# MONITORING YEAR 5 ANNUAL REPORT

## CANDY CREEK MITIGATION SITE

RE: **Draft Monitoring Year 5 Report Comments  
Candy Creek Mitigation Site (DMS #96315)**  
Cape Fear River Basin 03030002, Guilford County  
Contract No. 005794

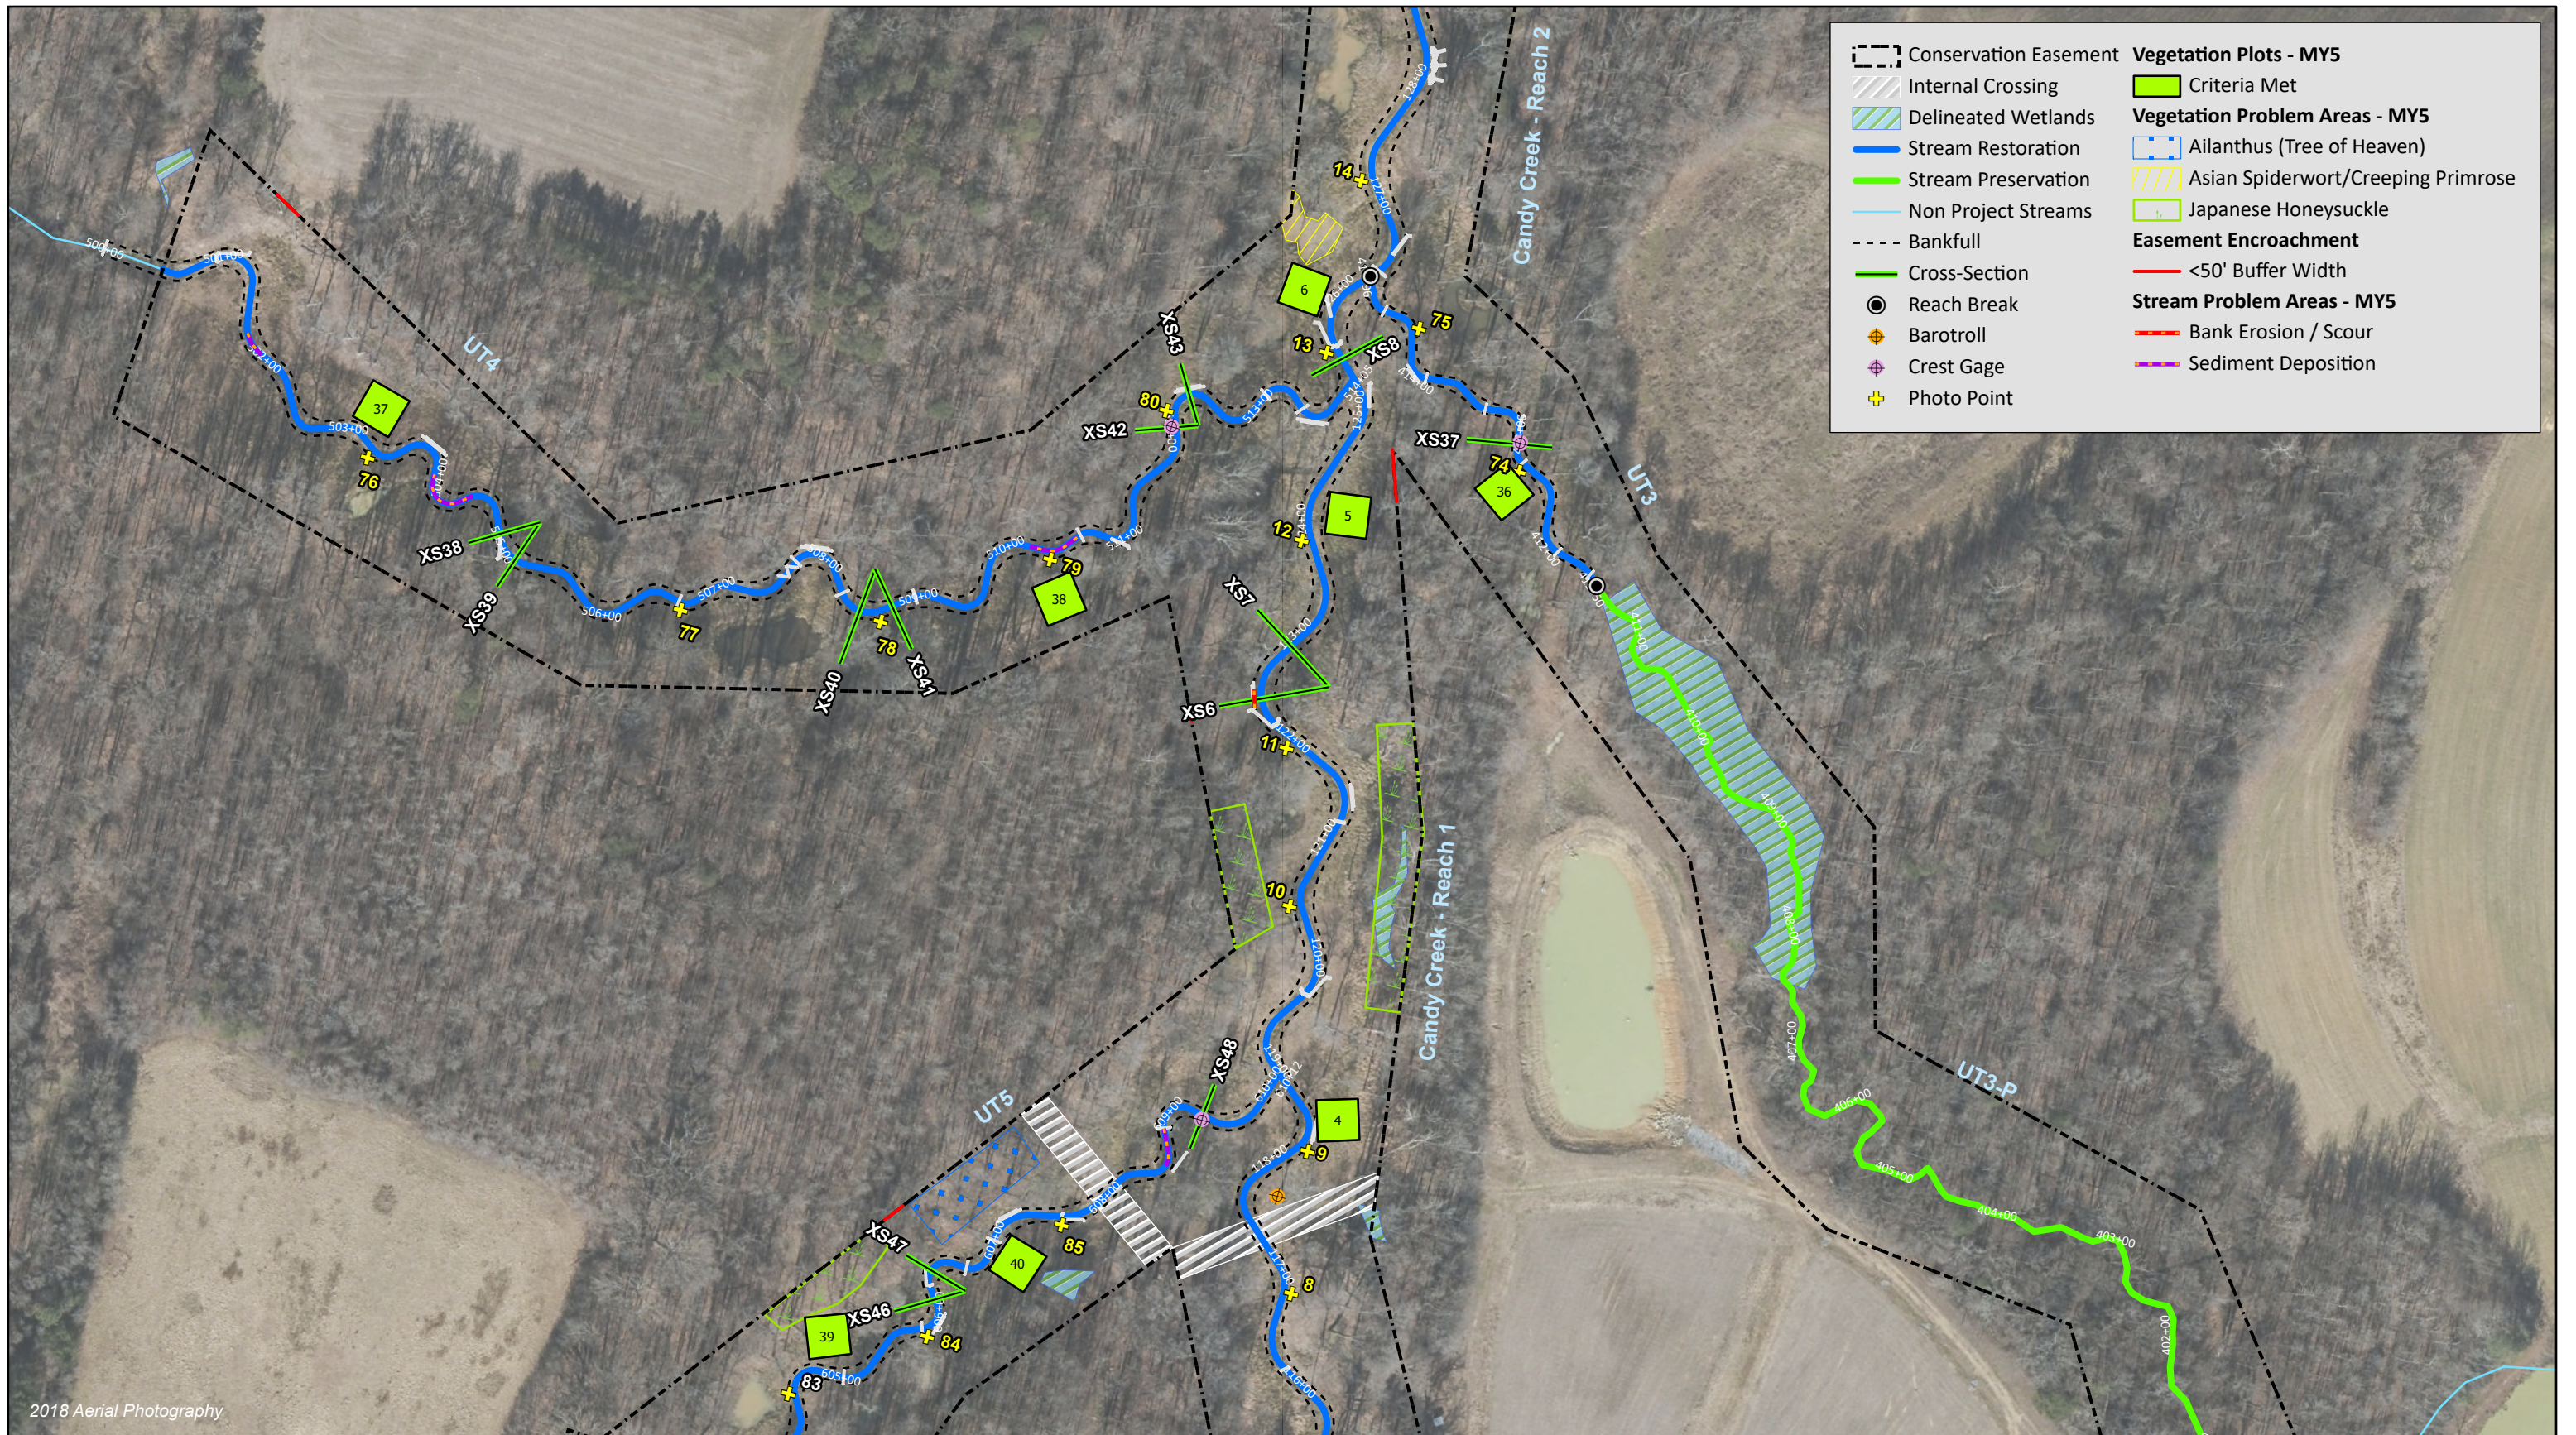
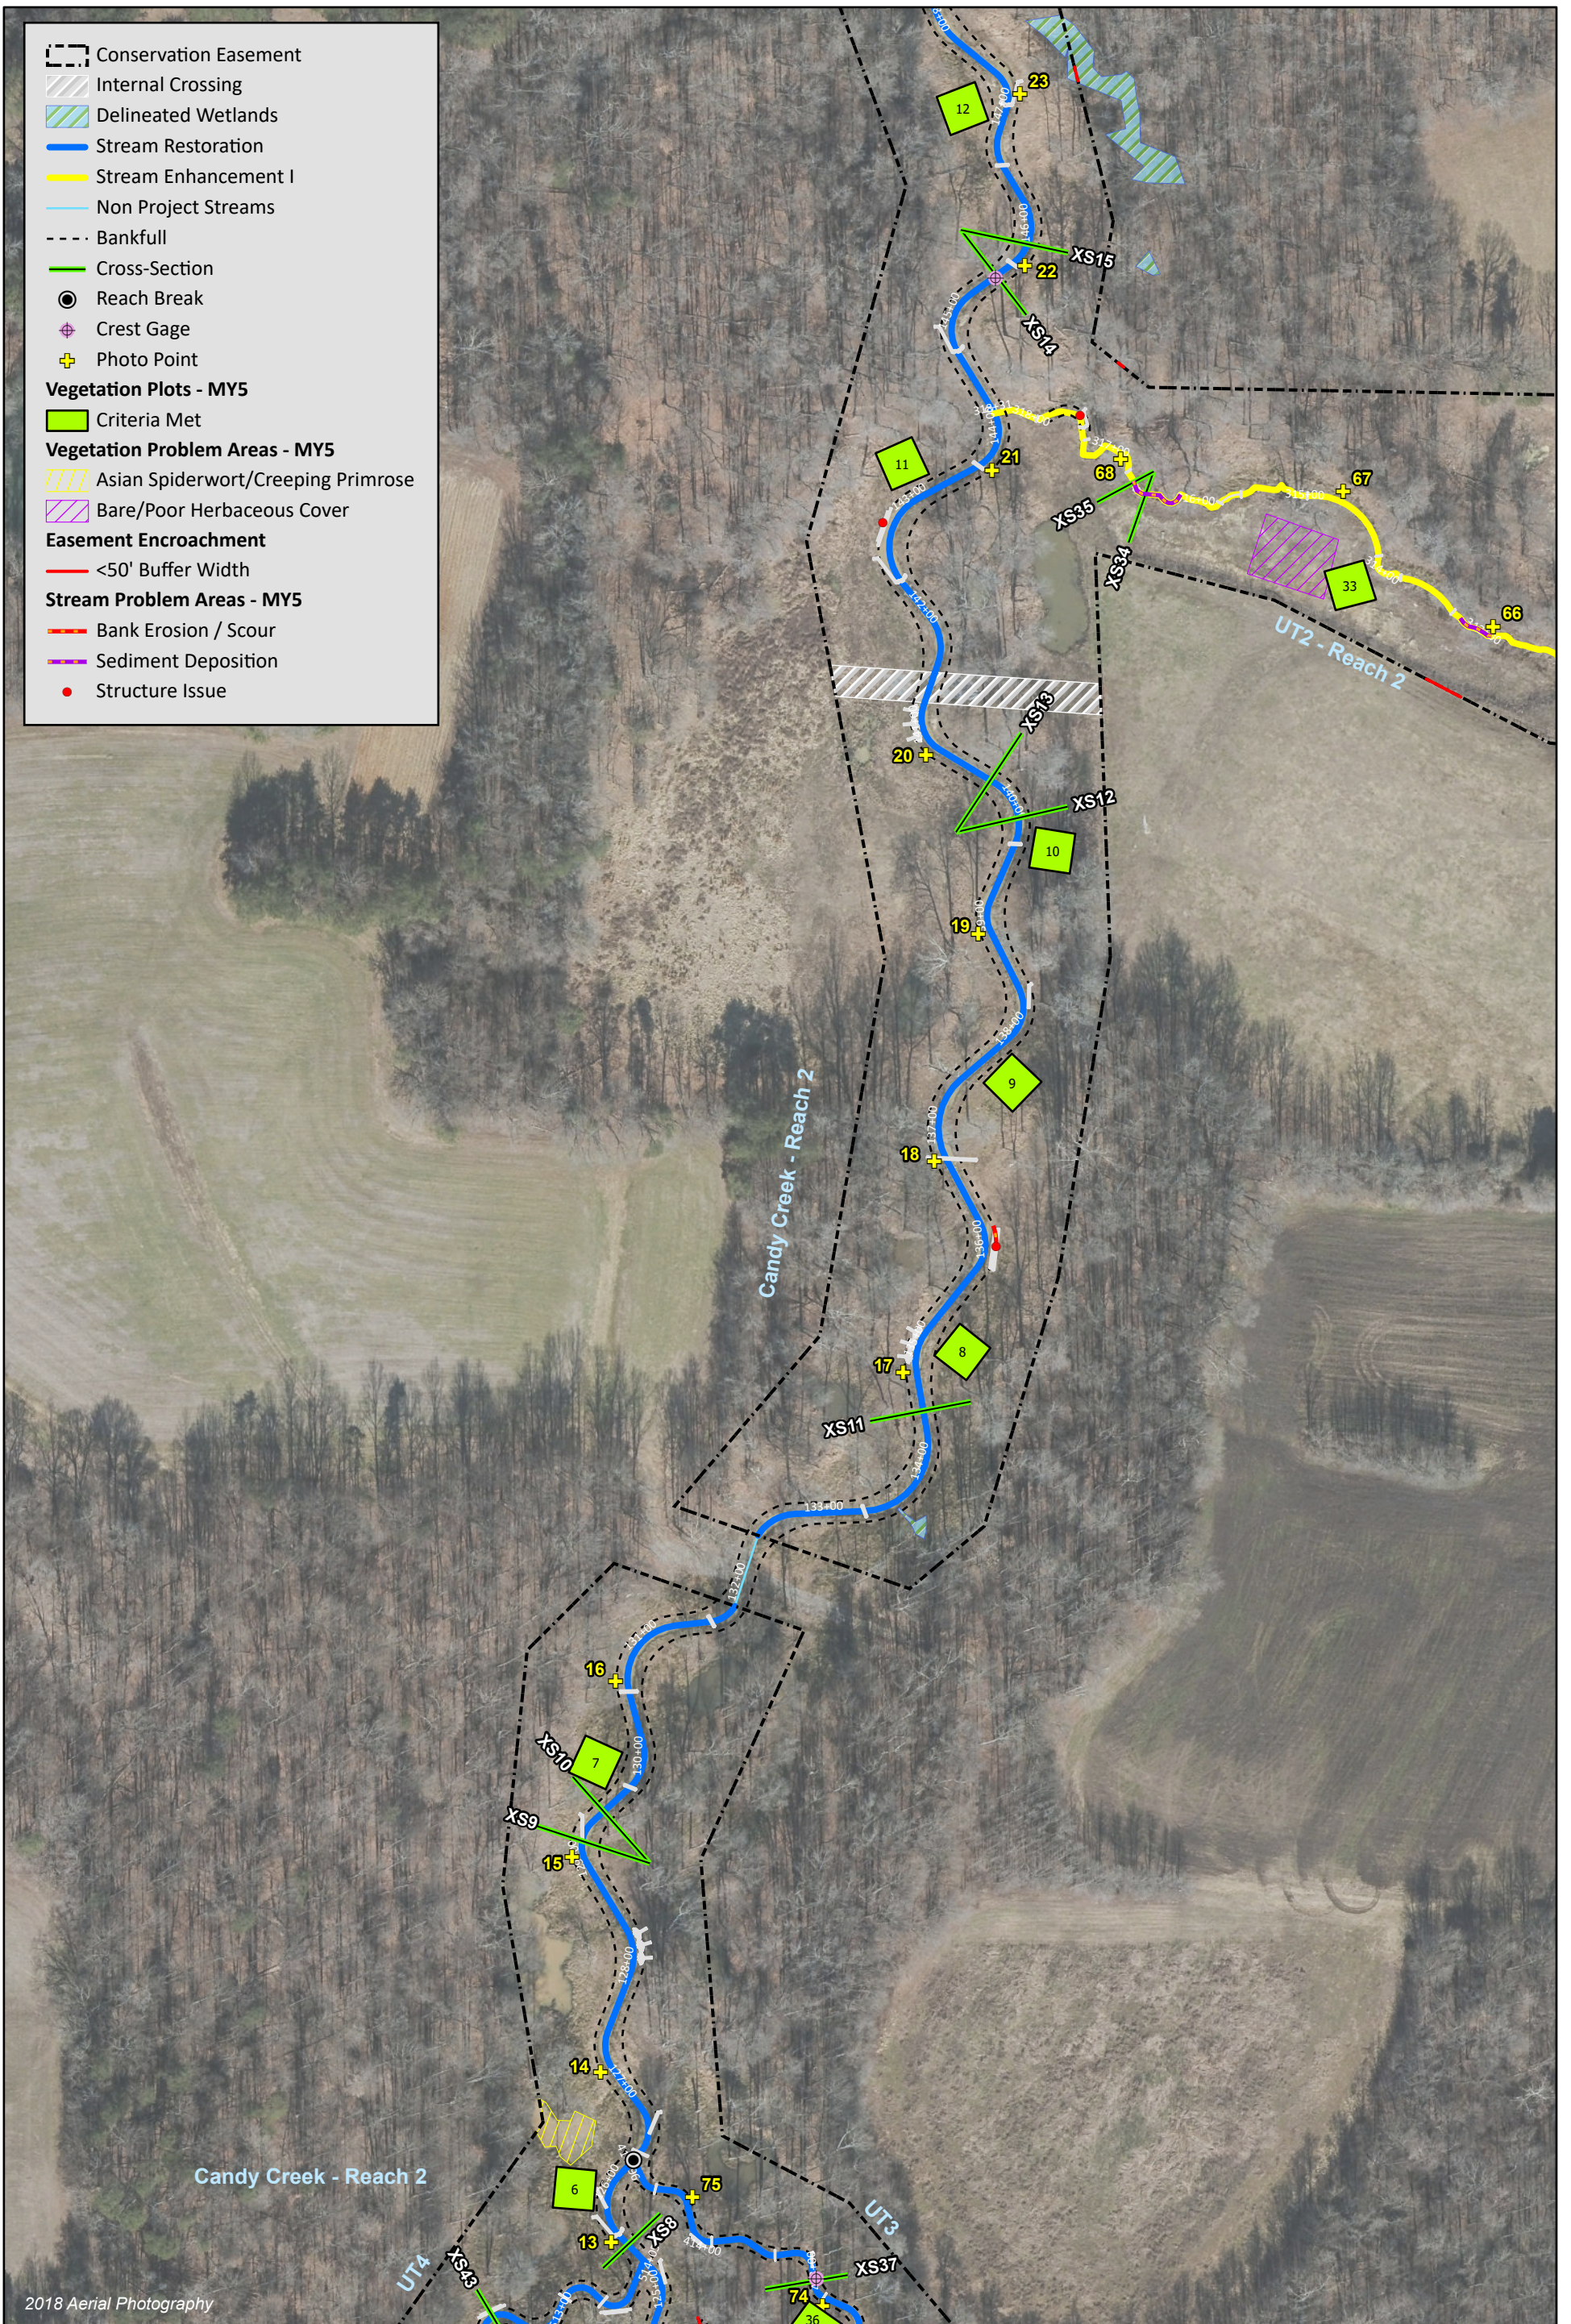
- a. **Please ensure that the stream areas of concern values reported in Table 5 reflect the submitted spatial data. For example, there are 2 aggradation features submitted for UT5 with a combined length of 130 ft, whereas Table 5m reports 3 segments with a length of 110 ft.**

*Wildlands' response: The submitted geodatabase, the associated figures (Figures 3.0-3.7), and the associated assessment tables (Tables 5a-5m) were checked and corrected so that the feature counts now match. For example, Table 5m now reports 2 segments of aggradation totaling 130ft, as shown in Figure 3.1; and the one structural issue for Overall Integrity on Candy Creek Reach 4 is now drawn on Figure 3.7. Where bed or structure issues overlap with an existing issue, notes were added to the attribute tables rather than adding additional features to the maps. For example, one of the aggradation issues mapped on UT4 and shown in Figure 3.2 and Table 5l, corresponds to two riffle condition-substrate and 1 pool condition-depth issues, which is now indicated in the attribute table.*
